# UNITED STATES PATENT AND TRADEMARK OFFICE

APPLICATION NO.	FILING DATE	FIRST NAMED INVENTOR	ATTORNEY DOCKET NO.	CONFIRMATION NO.
10/524,676	10/13/2005	Jens Otterbach	10191/3724	1465
26646	7590	09/21/2006	EXAMINER	
KENYON & KENYON LLP ONE BROADWAY NEW YORK, NY 10004			LAU, TUNG S	
			ART UNIT	PAPER NUMBER
			2863

<b>Office Action Summary</b>	<b>Application No.</b>	<b>Applicant(s)</b>	
	10/524,676	OTTERBACH ET AL.	
	<b>Examiner</b>	<b>Art Unit</b>	
	Tung S. Lau	2863

## **DETAILED ACTION**

FIG 1

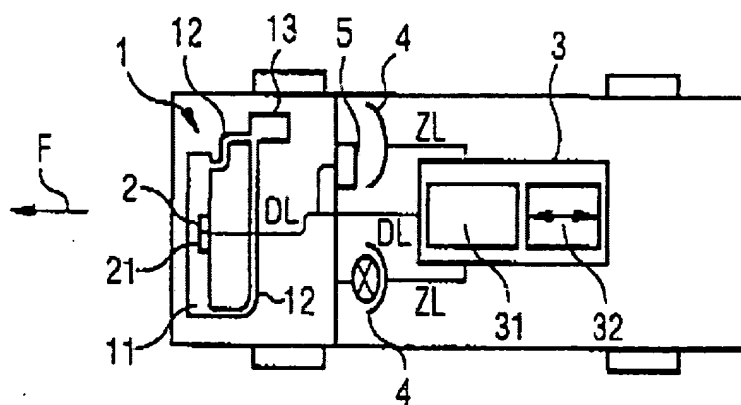
Grosshauser and Lorenz Pfau disclose a device (fig. 1) for impact sensing (page 2, lines 21-24), comprising: at least one pressure sensor (fig. 1, unit 2) to provide a signal; and a processor (fig. 1, unit 31) connectable to the at least one pressure sensor (fig. 1, unit 2) so that the processor performs the impact sensing as a

**Regarding claim 12**, Grosshauser and Lorenz Pfau further disclose at least one pressure sensor (fig. 1, unit 2) is arranged in a largely enclosed part (fig. 1, unit 12, mount inside the radiator), and the additional sensor is arranged outside of the largely enclosed part (page 4, lines 14, additional side impact sensor on the door also can be use outside of the radiator).

**Regarding claim 13,** Grosshauser and Lorenz Pfau further disclose a memory to supply the ambient pressure (fig. 1, unit 2, 31, microprocessor has memory to do calculation on fig. 2).

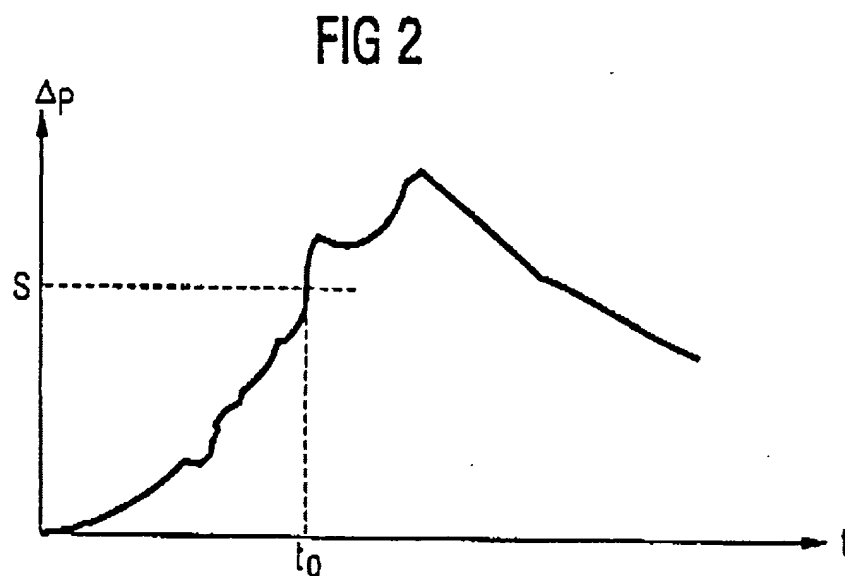
function of the signal (page 7, lines 9), wherein the signal is preprocessed (page 6-7, lines 23-2) so that the signal is normalized to a predefined pressure (page 8, lines 1-13, fig. 2).

**Regarding claim 10**, Grosshauser and Lorenz Pfau further disclose the signal is normalized to an ambient pressure (page 6, lines 12-22, fig. 2).

**Regarding claim 14,** Grosshauser and Lorenz Pfau further disclose at least one pressure sensor includes a sensor element (page 6, lines 3-12) configured to emit the normalized signal (page 6, lines 12-22, fig. 2).

**Regarding claim 15,** Grosshauser and Lorenz Pfau further disclose at least one pressure sensor (fig. 1, unit 2) is configured to normalize the signal (page 6, lines 3-22, fig. 2).

**Regarding claim 16,** Grosshauser and Lorenz Pfau further disclose the processor (fig. 1, unit 31) is configured to normalize the signal (page 6, lines 3-22, fig. 2).
